WHITEHORSE CITY COUNCIL SUBMISSION

# North East Link Urban Design and Landscape Plan Tram Road to Springvale Road

Endorsed by Council 13 October 2025

Approximate encroachment (red) recorded into Eram Park, totally approximately 19,000 sqm. (Red hashed area is within the City of Manningham).

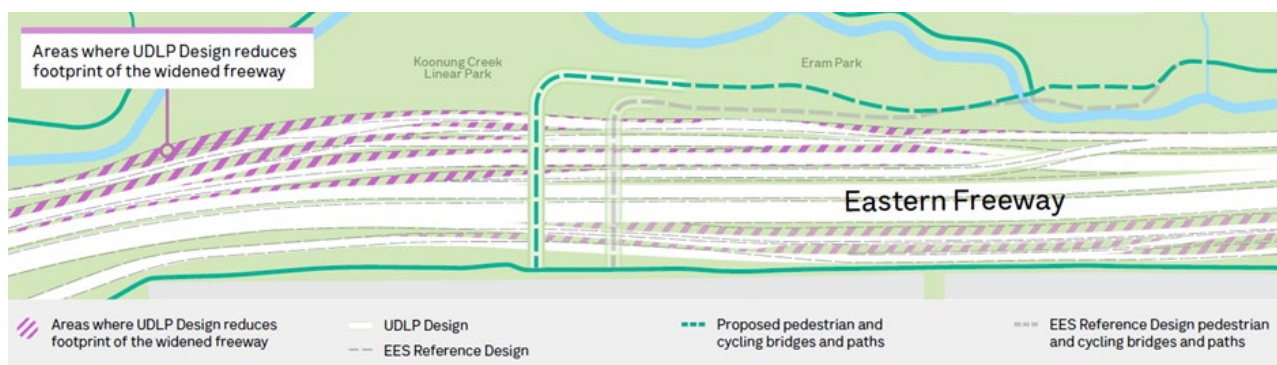
However, the remaining extents of the Eram Park precinct are relatively minimal in terms of the proposed improvements; especially within Eram Park itself. This is disappointing given the extensive impact of the long-term works during the construction phase and the open space reduction occurring within the park.

24. Whilst planting within the road corridor is proposed and appears to spatially accord with the demonstration of a minimised project footprint on Page 28 of the UDLP report, Councils strong preference is for any footprint minimisation to be delivered in the public open space network.

*Artist impression of the Eram Road pedestrian / cycle bridge.*

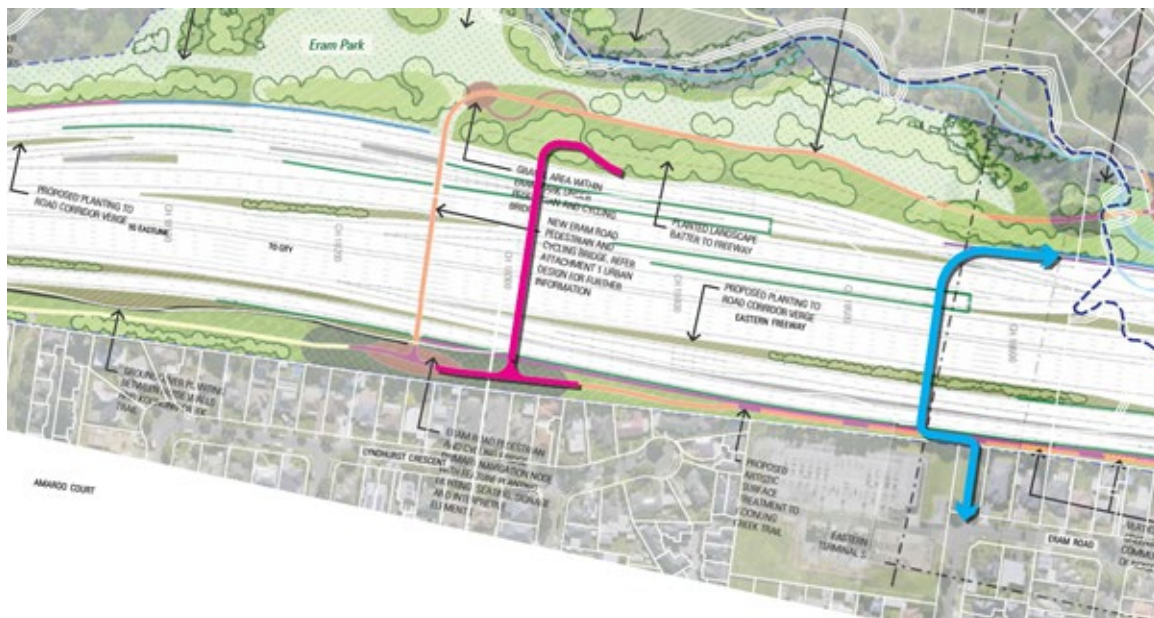
35. Council recognises opportunities to improve the Eram Road pedestrian and cycle bridge, specifically in relation to its location and accessibility; and the position of the ramping within Eram Park.
36. Council requests involvement in co-design and placemaking opportunities and urges for community input and awareness into these processes; to further advance the bridge design and community ownership of this infrastructure.
37. The bridge has been located approximately 300 metres west of Eram Road, which is approximately a 3 to 4 minute pedestrian walk. As indicated by the walking catchment mapping on page 30 of the UDLP Report, accessibility to the bridge lacks penetration into the southern street network compared to the existing condition; and by a reduced degree compared to the Reference Design.

Its position that is now *mid-block* between Eram Road and Lyndhurst Crescent will lack visual presence from the surrounding street network which is a significant concern for public awareness of this important “entry point”. It also lessens the opportunity for north-south pedestrian sightlines.

38. Despite the bridges positive design attributes articulated above, we disagree that its new position complies with *NEL Urban Design Strategy (UDS)* requirements and objectives including:

- a) *K4 1A – “Replace and relocate existing bridge near Eram Road over Eastern Freeway with a new walking and cycling crossing that connects to the Koonung Creek Trail and surrounding path networks. Entries to the bridge are to be clear, legible and are to include wayfinding to the entry points.”*
- b) *UDS Objective 2.1 – Connectivity: “Improve people’s ability to move through the immediate and wider area with ample, efficient and quality links across and along the corridor for all transport modes, including pedestrians and cyclists.”*

Suite of noise wall colours and demonstration of stepped transition in height

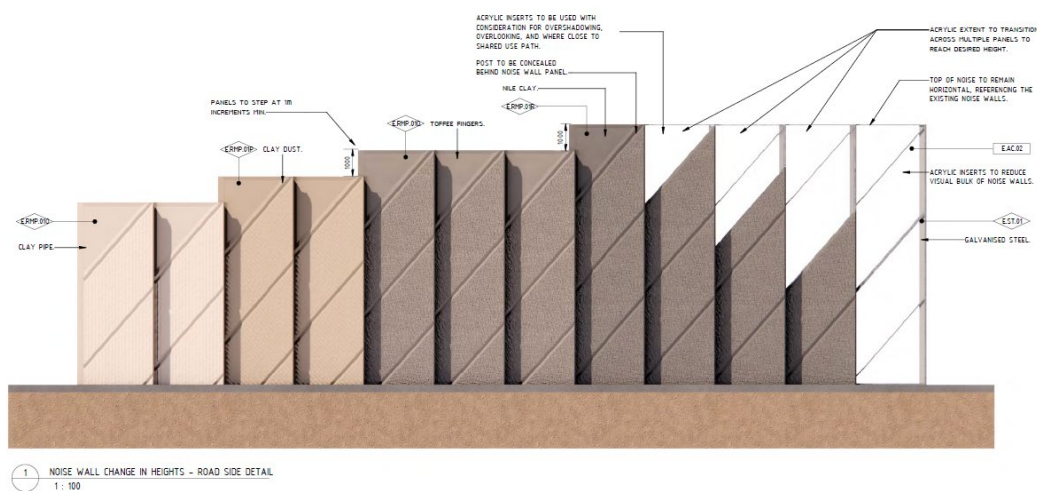
85. The suite of noise walls that are presented in the *Urban Design & Architectural Drawings Package* appear to have been well considered regarding their form, colour tones, texture and varying degrees of transparent acrylic applied. The design of these appears to have clear reference to the valued 1990s award winning noise walls which adopt natural tones and textures, contributing to landscape character.

86. *Page 56 of Attachment 1: Architecture and Urban Design* demonstrates how the transition will be achieved between varying noise wall heights. This stepped approach is effective as the transition is achieved in a gradual manner and avoids sudden transitions height.

87. Another positive attribute is how the staggering of connected noise wall panels is applied, as illustrated in typical scenarios within the *Architectural & Urban Design Plans*, is also effective in breaking up long segments of walls via vertical division while also providing added depth between connected panels.

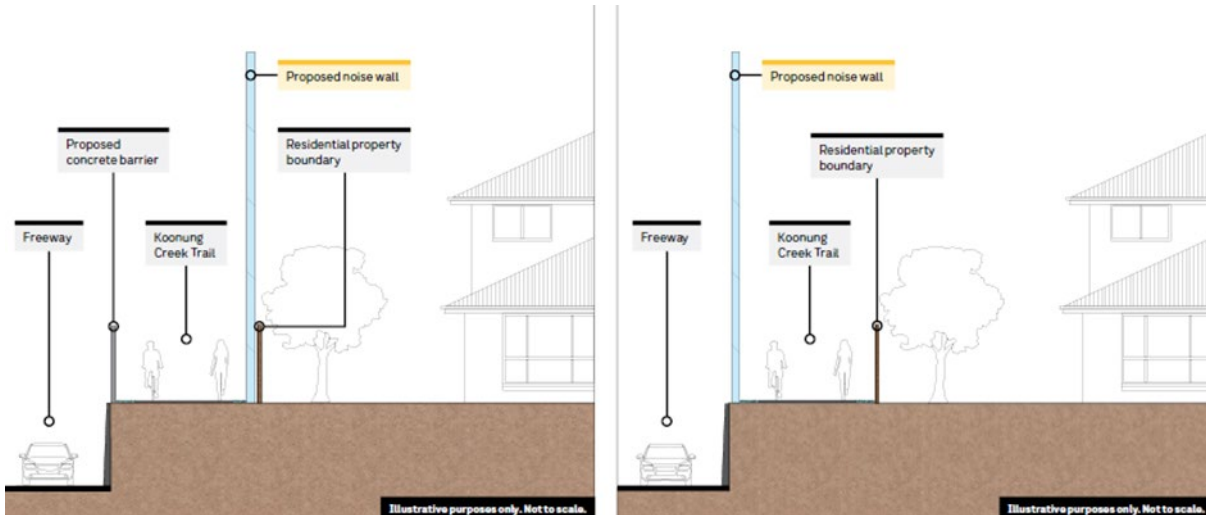
88. *Page 43* of the same document illustrates an example of noise walls positioned on sloping land in elevation form. These instances would likely present more sensitively if the noise wall steps with the slope in a similar manner to the stepped approach to transition.

Stepping with the land where practical would present as a lighter touch outcome and minimise the perception that they are forcefully positioned into the landscape.
